### **PLANNING BOARD**

Date: December 3, 2015

Subject: Convert existing structure from six offices and one residential unit to one office and six residential units (3 studios and 3 three-bedroom apartments)

Location: 1776 Beacon Street

**SITE PLAN**

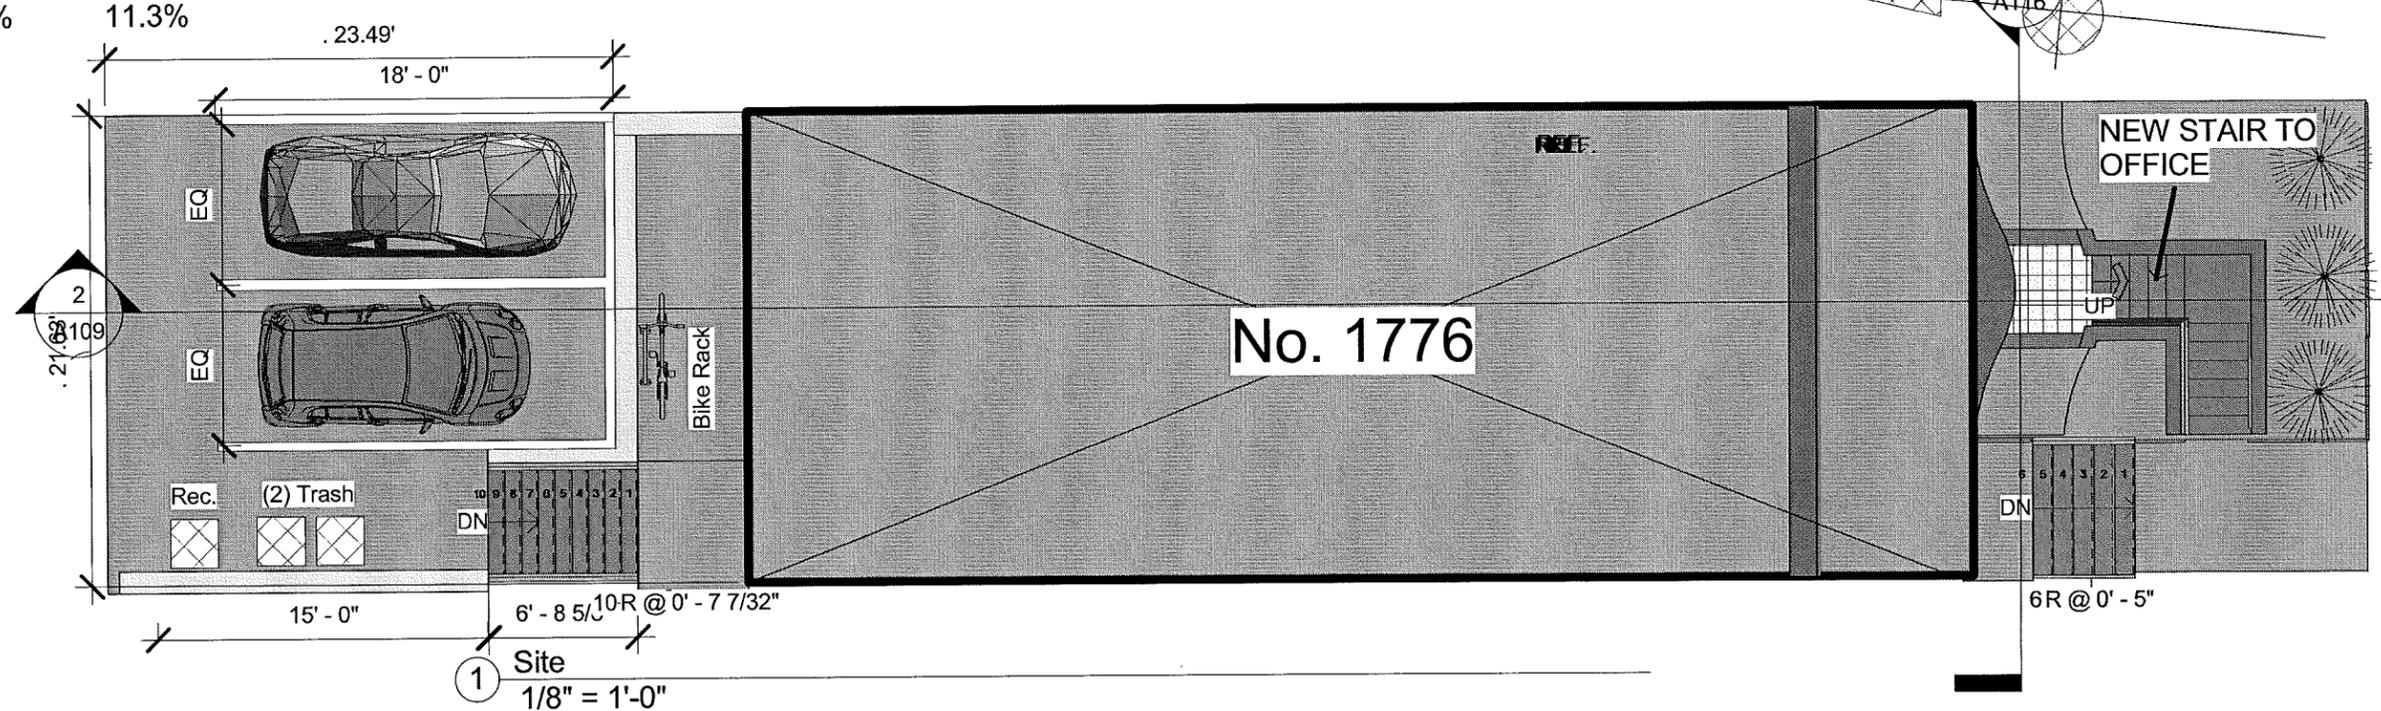
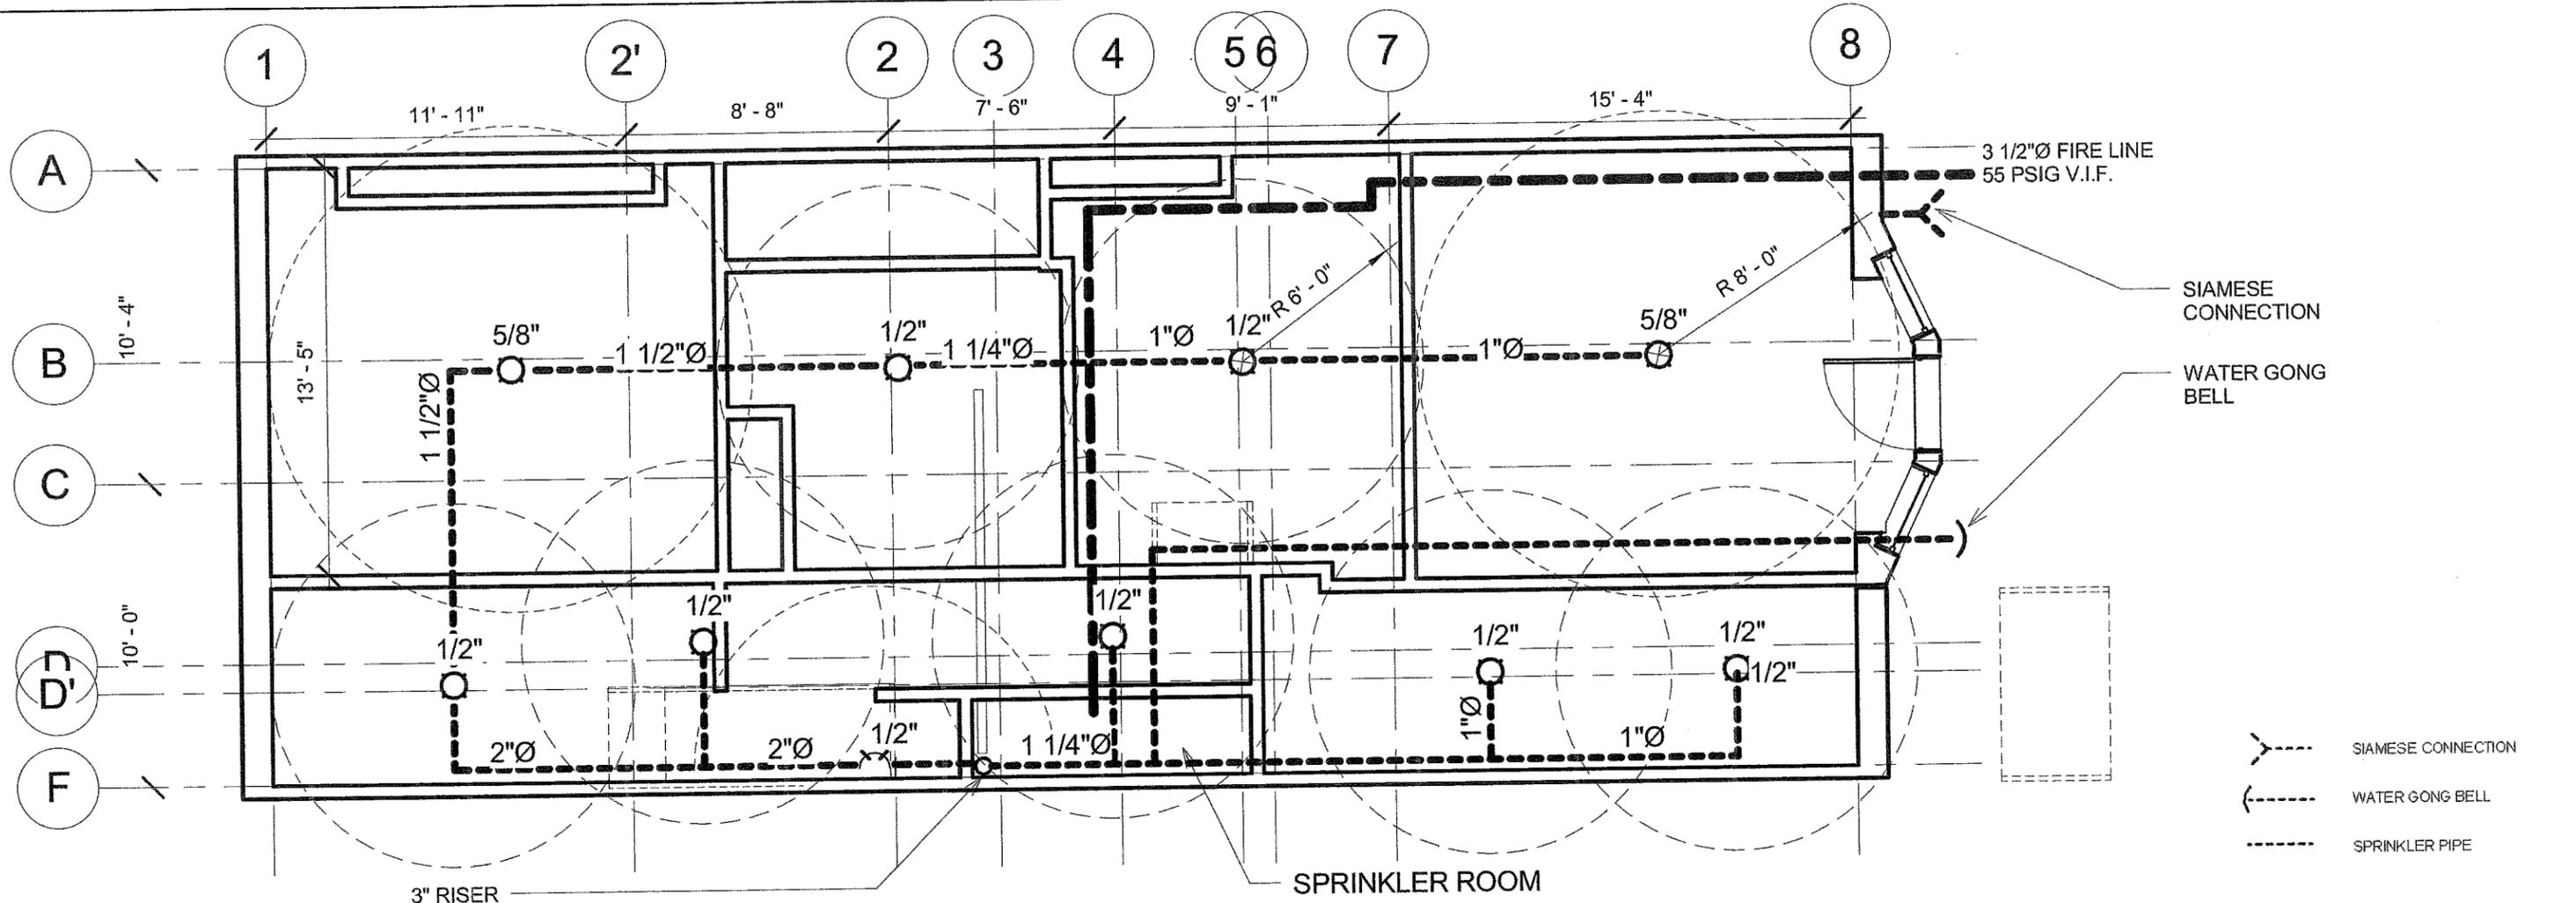
- a. Preservation of Trees and Landscape – Several existing plantings in the front-yard will be removed and the natural grade of the front-yard area will be altered in order to install the proposed basement entry. Despite this alteration/soil removal, the basement level entrance is consistent with the general appearance of neighboring structures, particularly amongst attached townhouses at 1774 and 1778 Beacon Street. Minimal landscaped open space will also be maintained on both sides of the proposed brick walkway.

- d. Open Space – The 1776 Beacon Street property does not comply with either landscaped open space or open space requirements for the M-2.0 district. This condition is pre-existing and the applicant proposes to maintain existing landscaped open space, insofar as practicable, within the front-yard. Additionally, the Applicant proposes to install new landscape features within the existing front yard.

- 2. Prior to the issuance of a building permit, the applicant shall submit a final landscaping plan for the front-yard area along Beacon Street, subject to the review and approval of the Assistant Director for Regulatory Planning.**

**Elevation: Front- South**

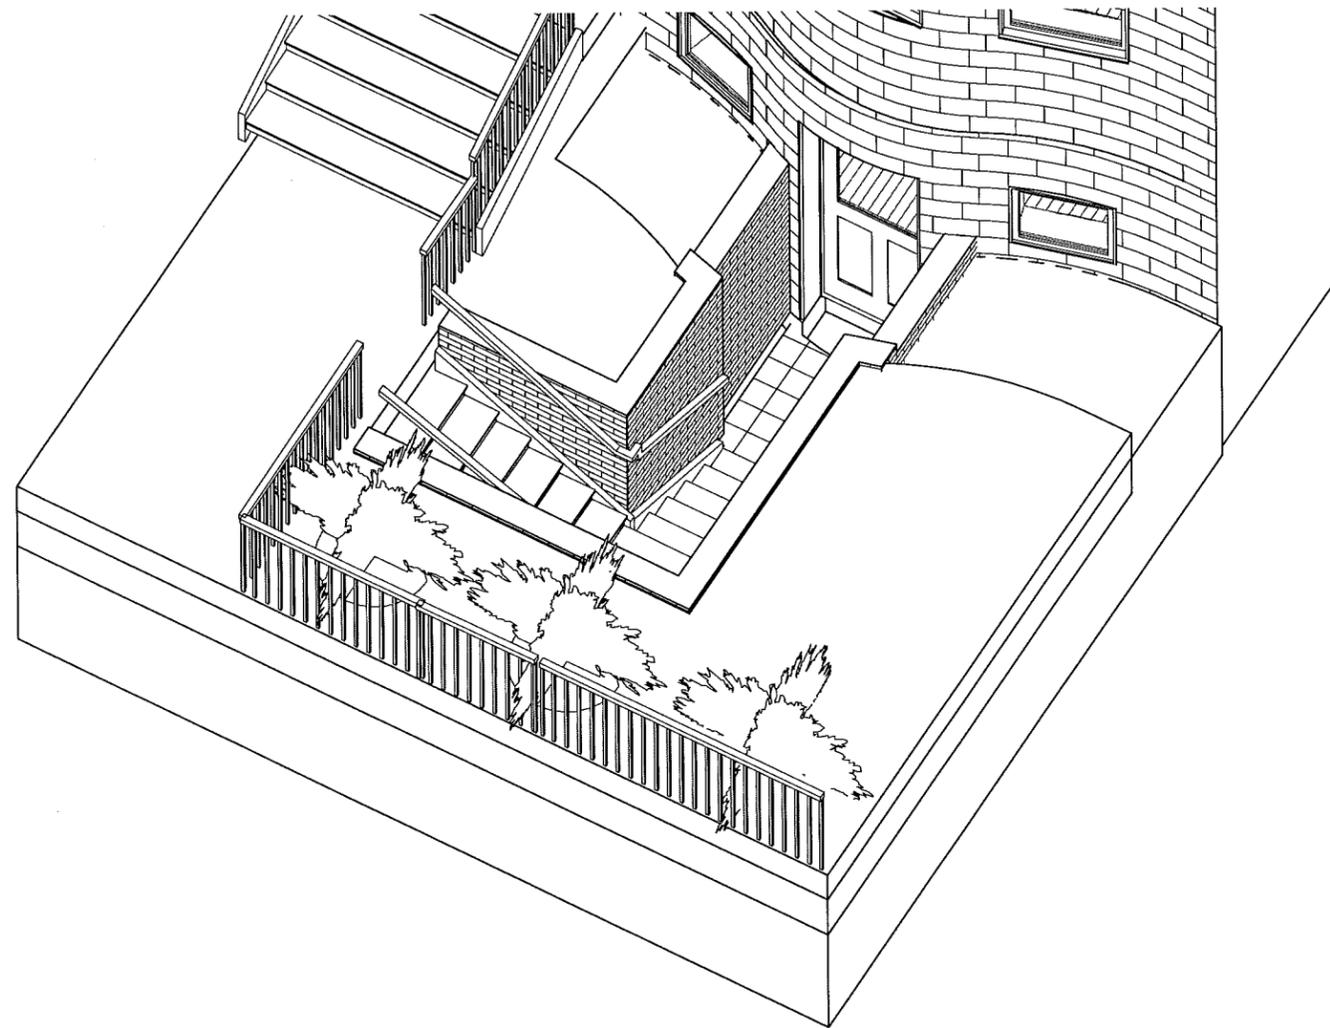
Basement level façade alterations do modify the existing streetscape but in a manner that is not inconsistent with attached townhouses. The single staircase design down to this new basement entry requires far less excavation and foundation alteration than the neighboring basement entry at 1774 Beacon Street but the Planning Board does recommend that this staircase be angled to meet the existing front walkway rather than extending directly to the Beacon Street sidewalk. The Planning Board also recommends that all exterior repair/repointing should be completed

using a grout component that is not stronger than existing brick, e.g. lime-sand composite, in an effort to maintain design consistency within this National Register District. Similarly, the Planning Board recommends the submission of final plans for any window replacement indicating profile, color, and materials. In general, the Planning Board recommends wood rather than metal or aluminum for any potential window replacement.

- 1. Prior to the issuance of a building permit, the applicant shall submit a final site plan including the front staircase configuration, provided off-street parking, and the location of all trash/recycling facilities, final floor plans including gross floor area calculations, a final front elevation including all window and door dimensions, and a final building section that specifically details the new basement level entryway, subject to the review and approval of the Assistant Director for Regulatory Planning.**
